GC0186: Proposed Grid Code Changes – Post Electricity System Restoration Standard (ESRS)

Workgroup Meeting 2

Presentation – Protection system risks during ESR Testing

Energising Clean bar

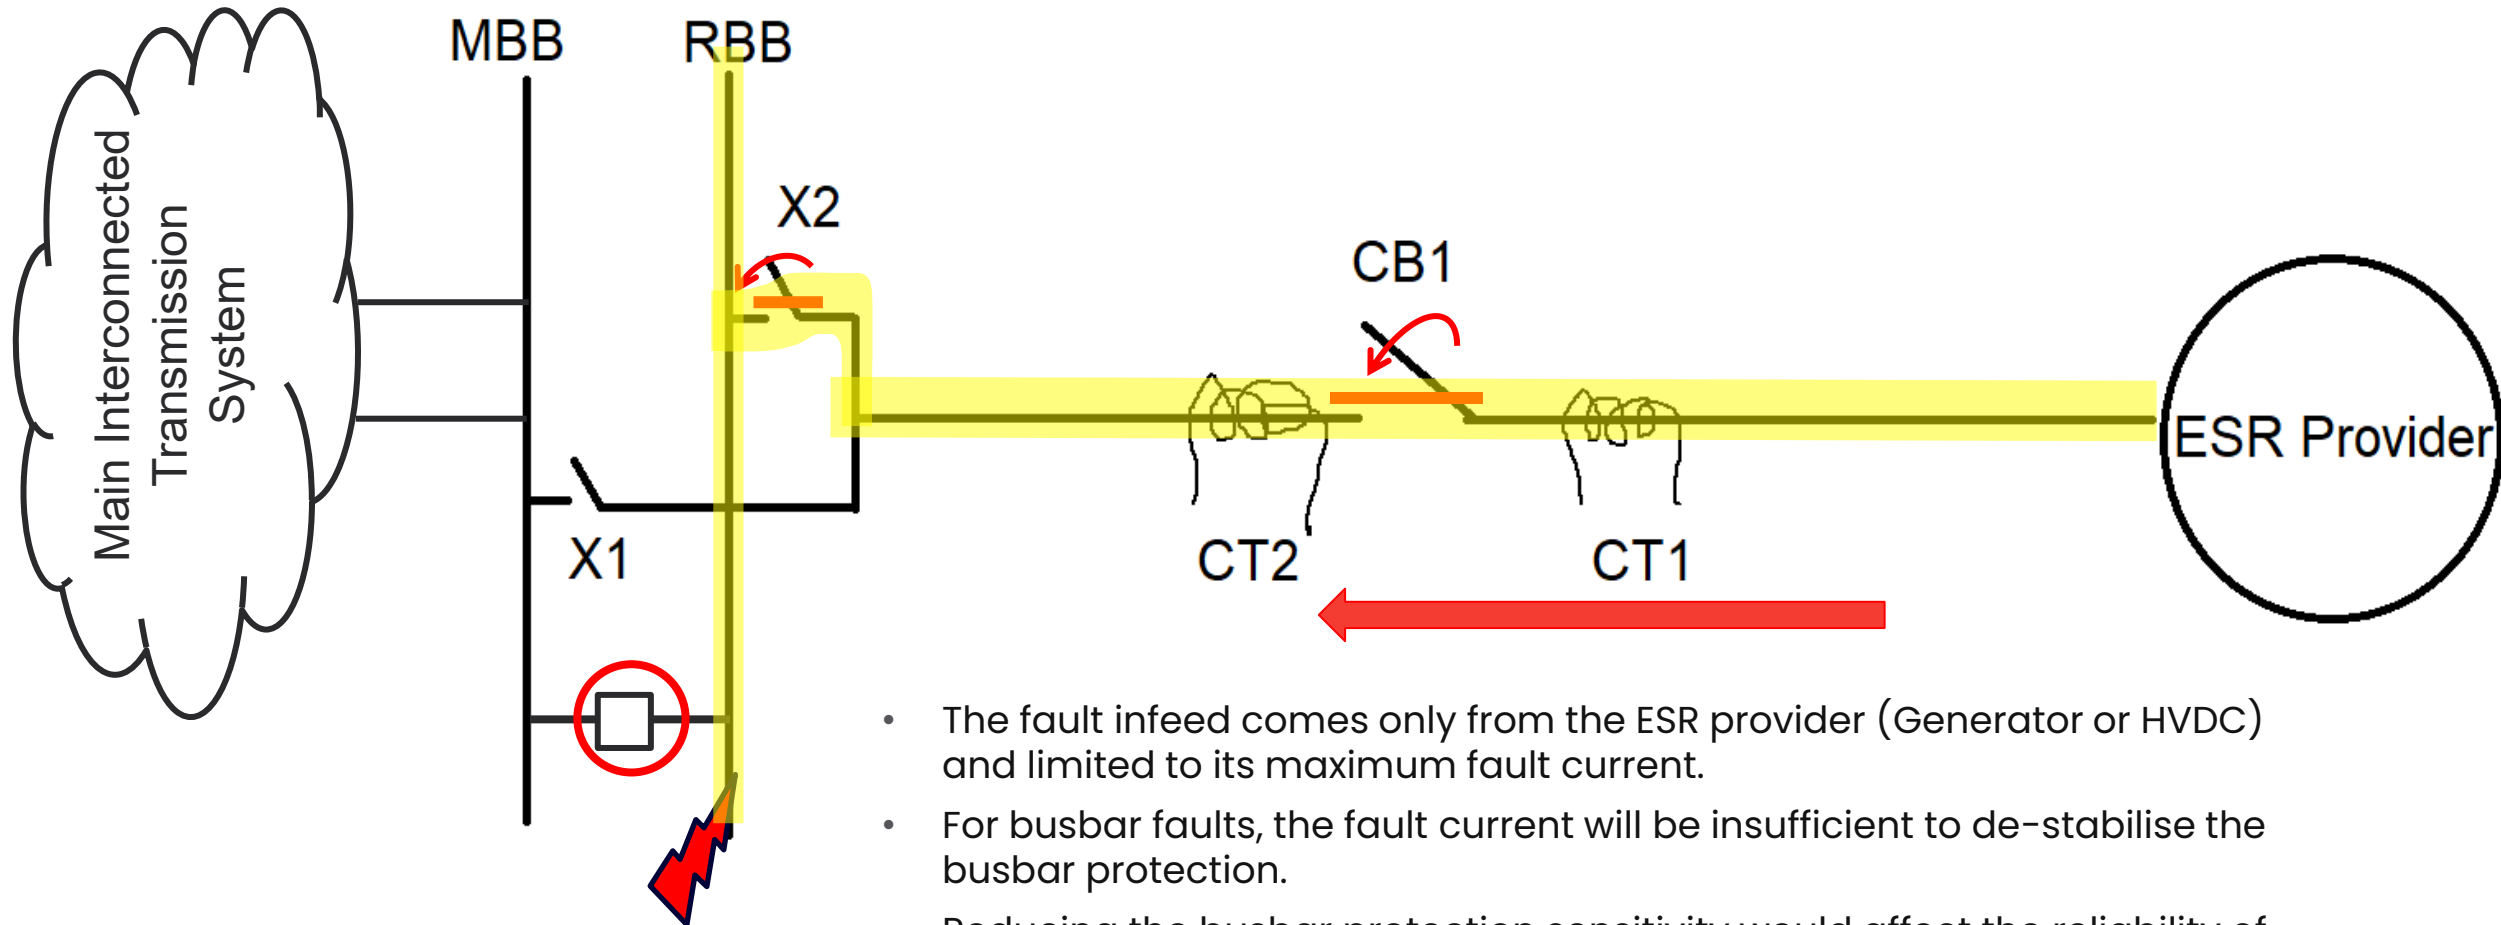
- The fault infeed comes only from the ESR provider (Generator or HVDC) and limited to its maximum fault current.
- For busbar faults, the fault current will be insufficient to de-stabilise the busbar protection.
- Reducing the busbar protection sensitivity would affect the reliability of the live system (i.e. MBB).

Available options

Energise to the open CB

This limits the test to the generator's open CB which elements the busbar faults. However, if the TO owns an asset(s) between the transmission level CB and the generator, the TO would still need to clear the fault on these assets. In that case another CB and/or isolator should be opened. Sometimes this is not feasible due to interlocking schemes.

Change the overcurrent relay settings

If eliminating the TOs owned assets from the test is not feasible, the setting of the existing O/C relays (if available) should be modified on the test day to provide fault clearance. **This requires additional hours during the test as well as long notice to allocate resources and run simulation studies**

Install a temporary overcurrent relay

If there is not any O/C, a temporary O/C must be commissioned before the test and decommissioned upon the completion of the test.

This a major piece of work and will require work on a live busbar. Therefore, **it requires extended outage to commission and decommission the relay as well as long notice** to allocate resources and run simulation studies
